BOARD ACTION REPORT – APPEALABLE ITEM

Project Name: 411 E. Atlantic Avenue
Project Location: 411 E. Atlantic Avenue
Request: Approval of a Class I Site Plan Modification
Board: Site Plan Review and Appearance Board
Meeting Date: January 9, 2019

SITE PLAN REVIEW AND APPEARANCE BOARD STAFF REPORT

File No.: 2018-177
Class I

1 SOUTH ELEVATION PROPOSED
A-200.1 SCALE: 3/16" = 1'-0"

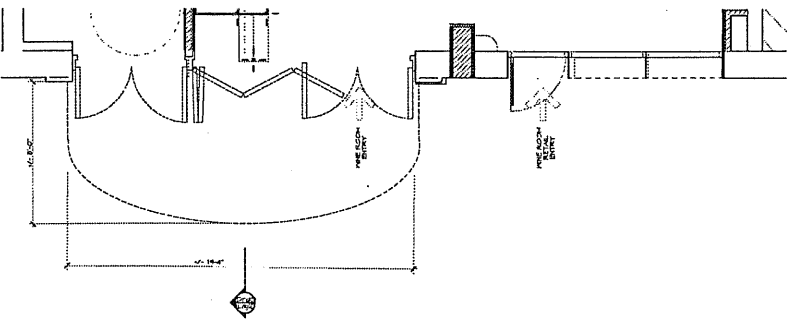
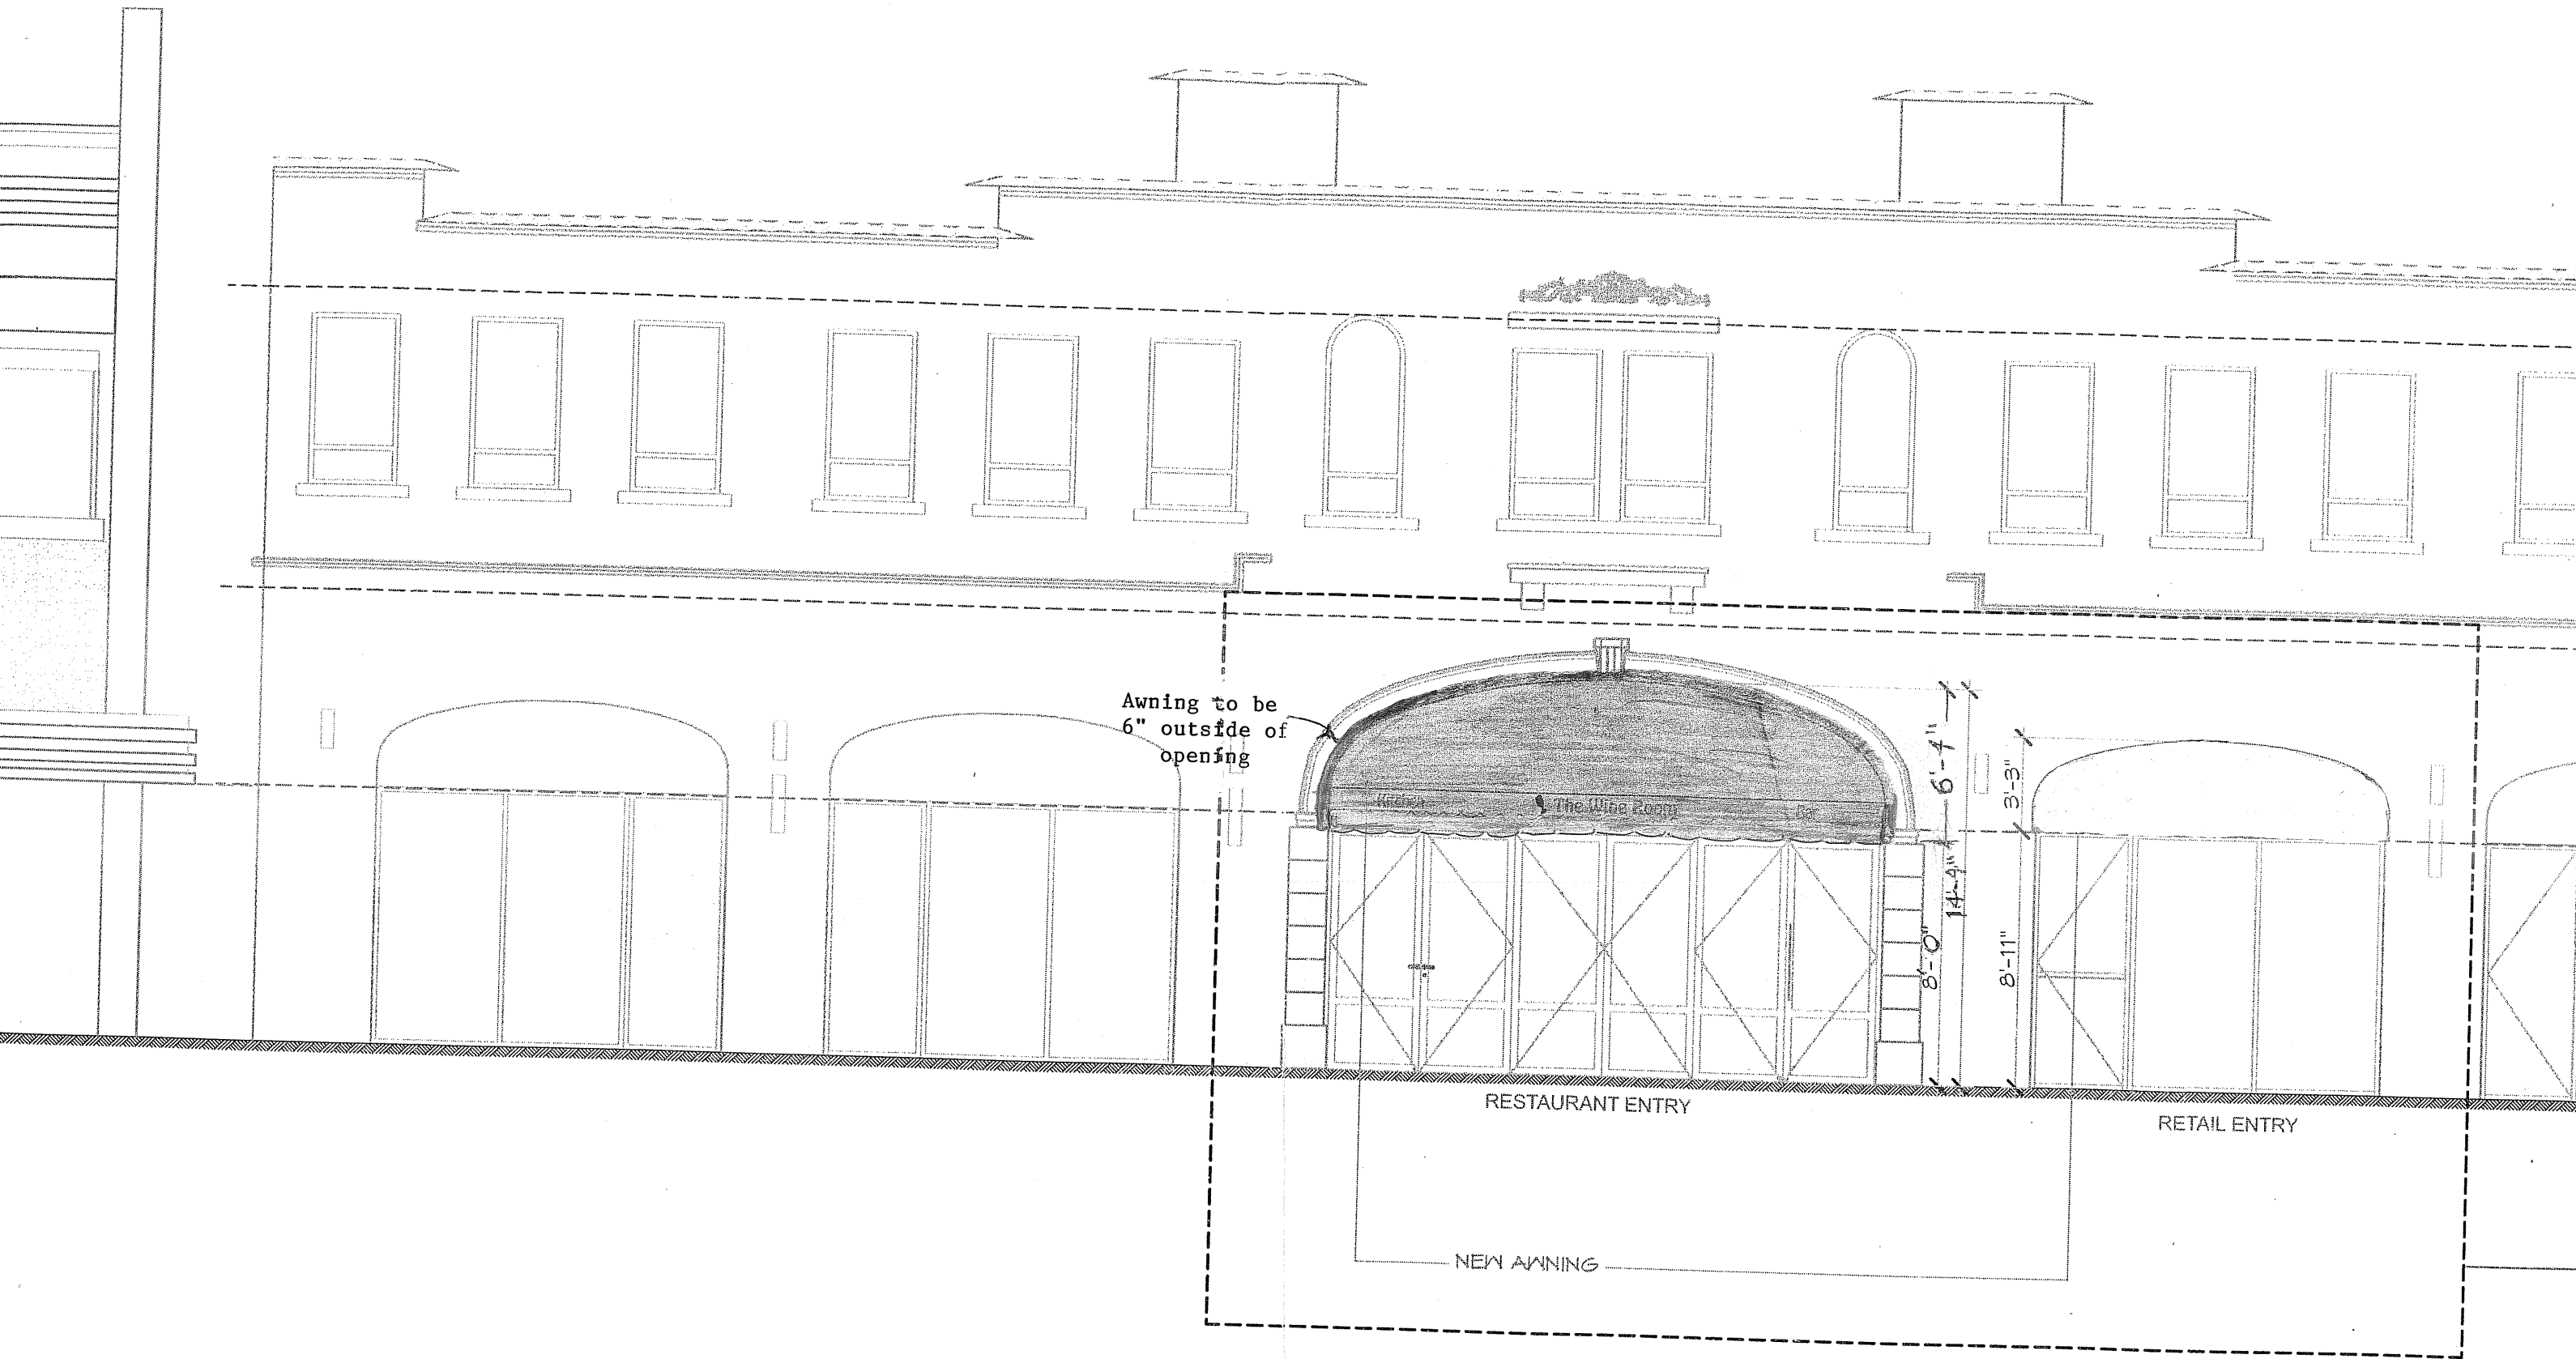
Approved (6-0 Annie Adkins Roof absent) the amendment to the sign program for 411 E. Atlantic Avenue with the condition the piping of the awning is the same color of crème as the lettering of the sign.

- That a hold harmless agreement be approved and recorded for the canopy prior to issuance of a building permit.
- That the original masonry archway be reinstalled prior to the awning installation and issuance of the canopy permit
